Subject: Collin County Healthcare Facility, Parking Garage, and Medical Examiners  
Revised Request for Change (PCO) No. 015; RFI #86 HC Fire Pump Confirmation

**Issue No. 015 - RFI #86 HC Fire Pump Confirmation**

Re: Collin County Medical Campus  
Request for Proposal – RFI#86  
GME Proposal X911 Credit Healthcare Fire Pump  
GME Project #GME-24-009

**SHEET TITLE**  
SINGLE LINE DIAGRAM

**SD-E5.01**

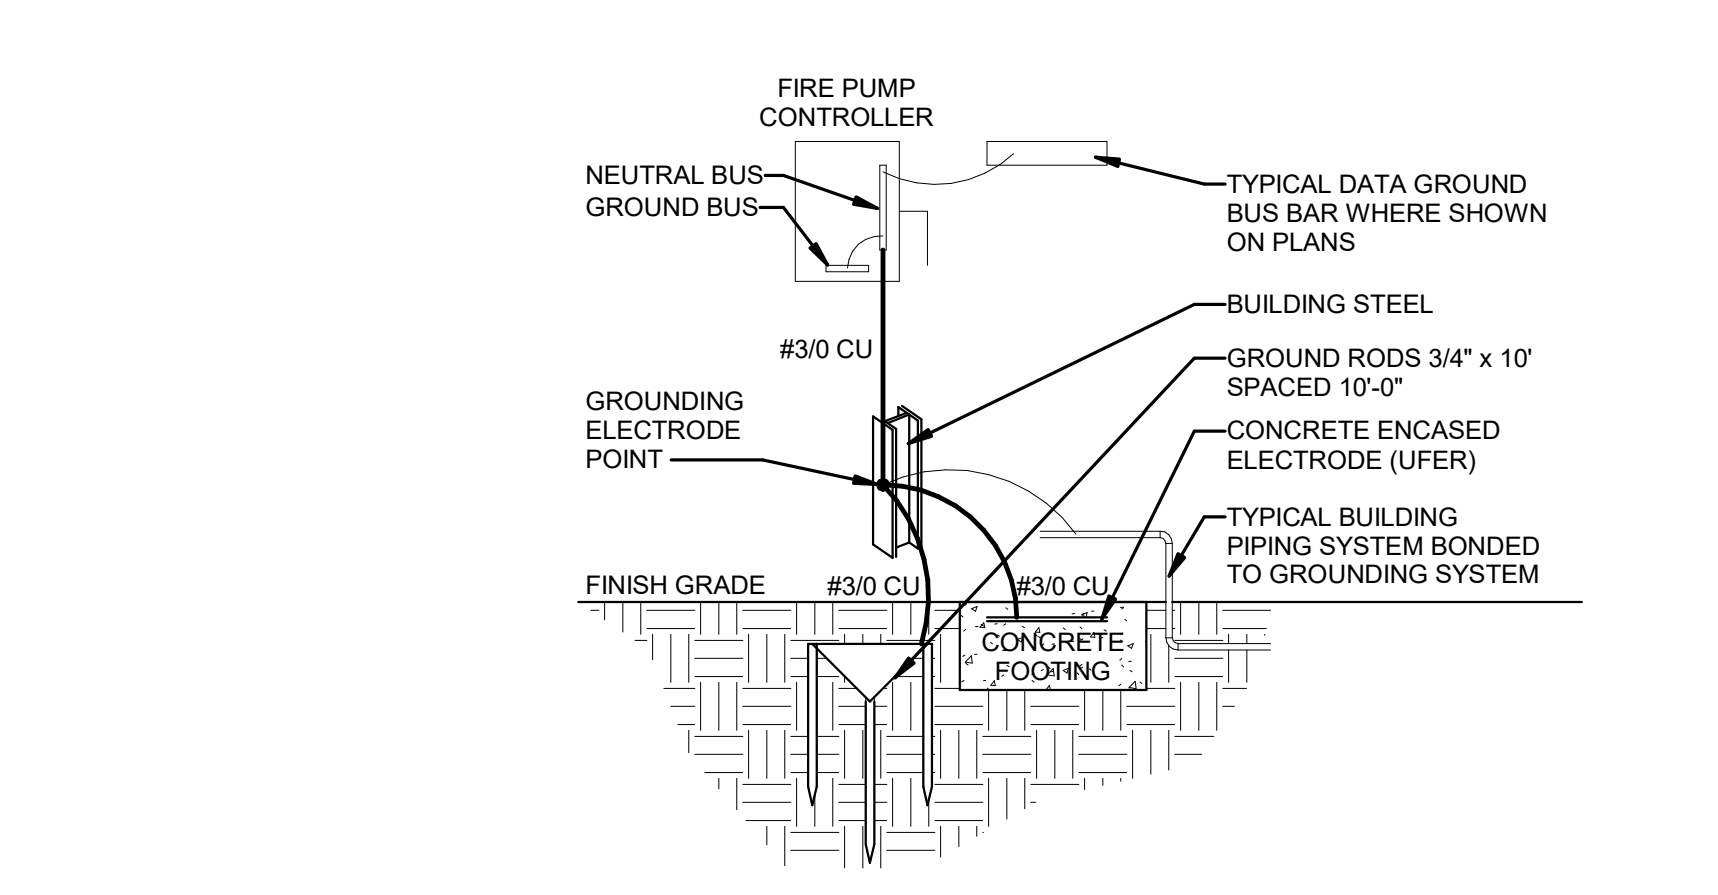
- **Per RFI #86 response.**
- **Healthcare Facility**
  - **Credit for the removal of the fire pump.**
  - **Credit for 1,809' of (4) #300AL and labor.**
  - **Credit for wire, termination, materials and labor for fire pump controller and fire pump.**
  - **Credit for fire pump terminations at Transformer T2 was given back in previously submitted PCO #032 ASI #3 Medium Voltage Scope of Work.**
- ***This PCO will be a deduct to our contract in the amount of \$-45,109.***

1. No credit on 4" pvc from HC to generator yard has been roughed in.
2. Credit for 1809' of (4) #300AL and labor.
3. Credit for wire, termination, materials and labor for fire pump controller.
4. Credit for wire, termination, materials and labor for fire pump.
5. Credit for fire pump terminations at Transformer T2 has already been given back.
